81142A-01A-S

S E R V I C E N O T E

81142A – High Speed Pulse Generator

POSSIBLE FIRE HAZARD

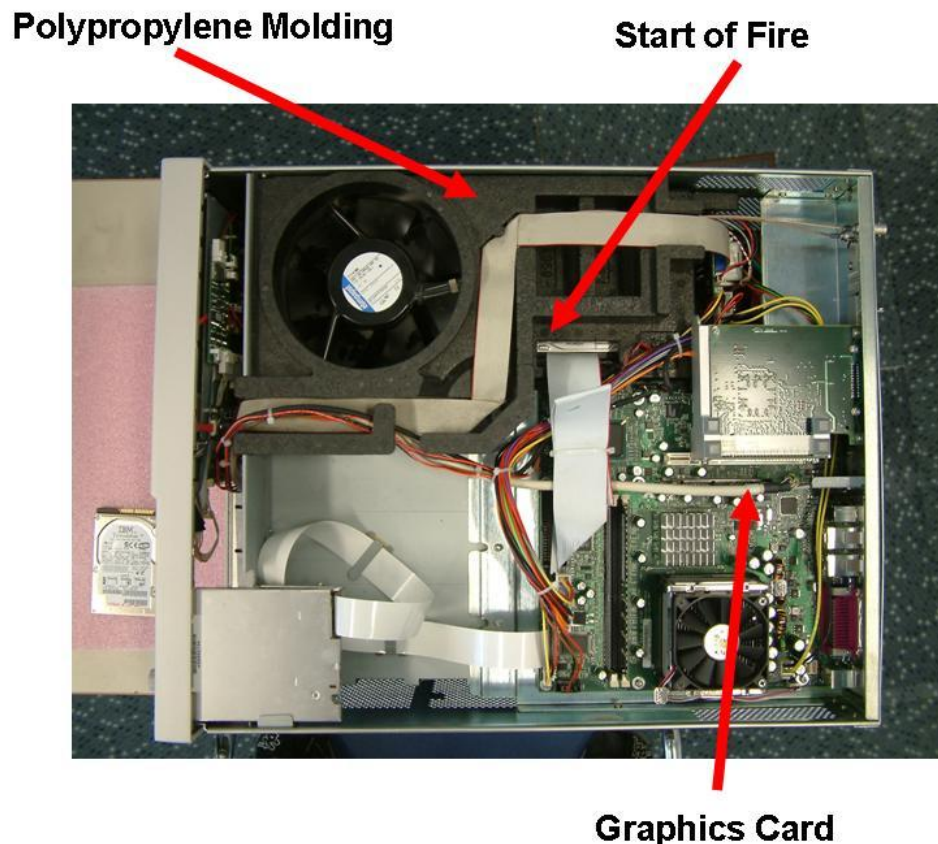
A surface-mount ceramic capacitor suffered physical stress during the manufacturing process, leading the capacitor to crack. During operation this crack placed stress on the internal structure of the capacitor, and caused the plates to short together. (The plates are separated by very little space, made up of very thin insulators.) This caused the capacitor to have very low residual impedance, resulting in a very high current conducted through the capacitor and the 12V path on the motherboard for some period of time. The low impedance didn't lead to a current high enough for blowing the fuse. Therefore the higher current was available long enough to create a very high temperature ($T > 300^{\circ}\text{C}$). The high temperature ignited the polyurethane molding used to conduct the airflow for cooling through the instrument.

The following photo illustrates the layout of the instrument. It shows the polypropylene molding, the graphics card and the starting point of the fire.

The countermeasure for this issue is to exchange the graphics cards. The new graphics cards are produced with an improved manufacturing process eliminating the risk of micro cracks. They either have an additional fusing to protect the 12V path or they have eliminated the 12V path altogether. The graphics card can be exchanged by Agilent authorized personnel only.

- Sample #1 (Revision NM2501):

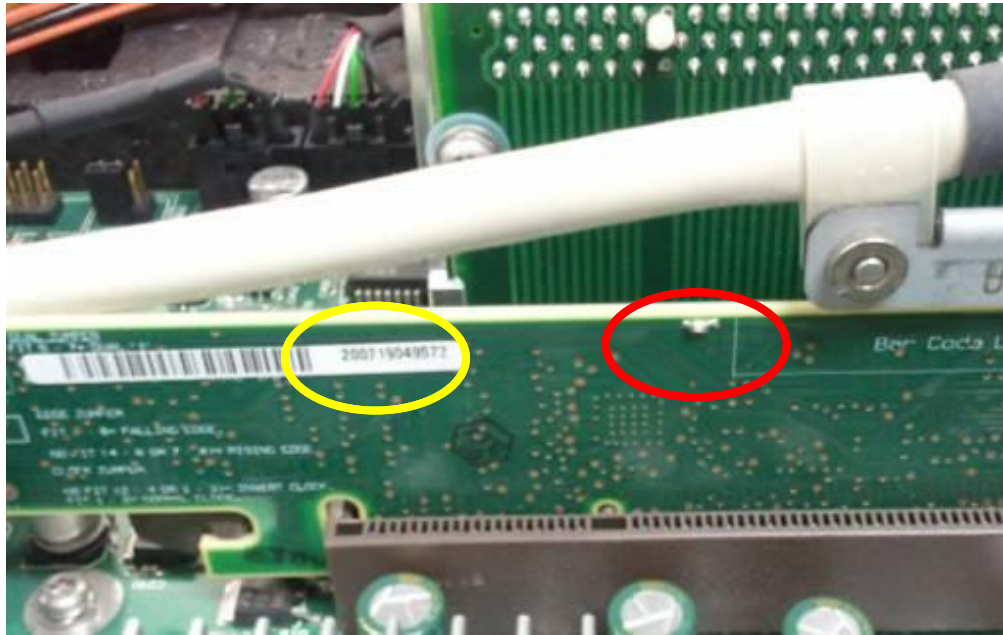
The board has a fuse on top (red circle) and a serial number (yellow circle) starting with 200... In the case above it is 200719049572)

- Sample #2 (Revision NM2502):

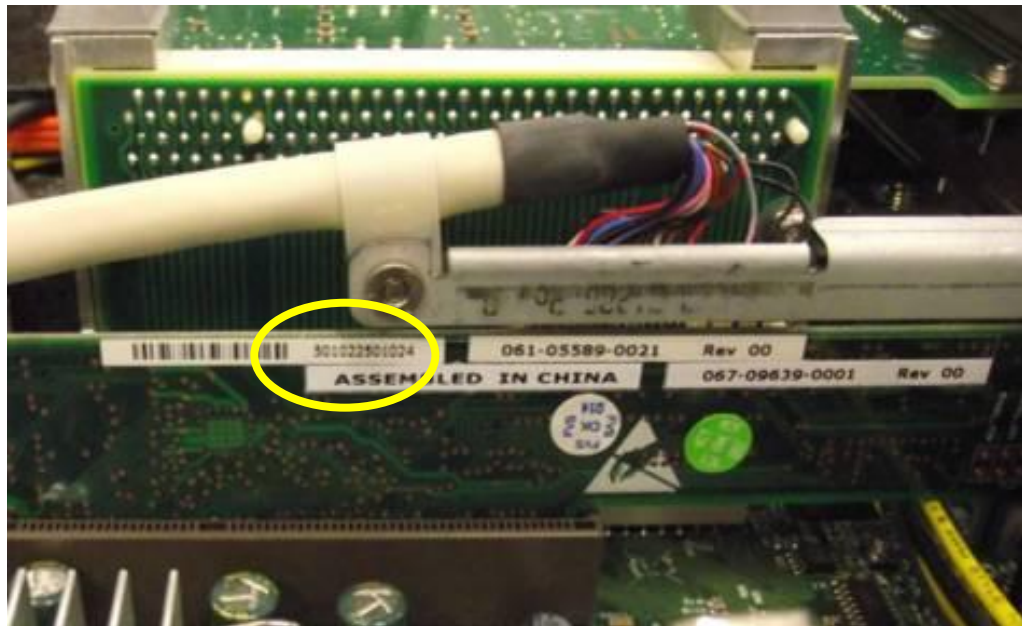
The board has a serial number (yellow circle) **NOT** starting with 200... In the case above it is: 501022501024.

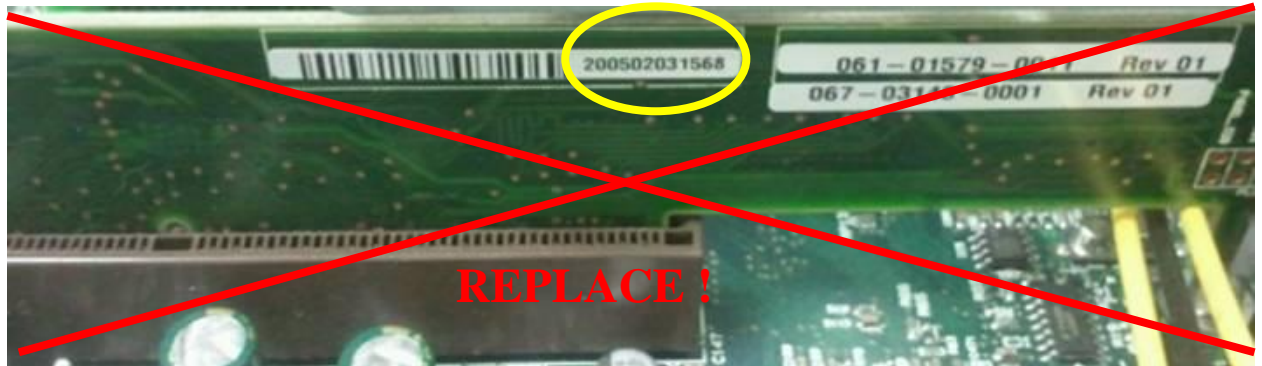
If the graphic board

shows a serial number starting with 200... AND no fuse is visible

it is potentially **hazardous** and the **unit must be set out of operation** until the graphic board is replaced (part number: N4901-66577 or N4901-69577). The graphic board can be exchanged without impacting the instrument's performance.
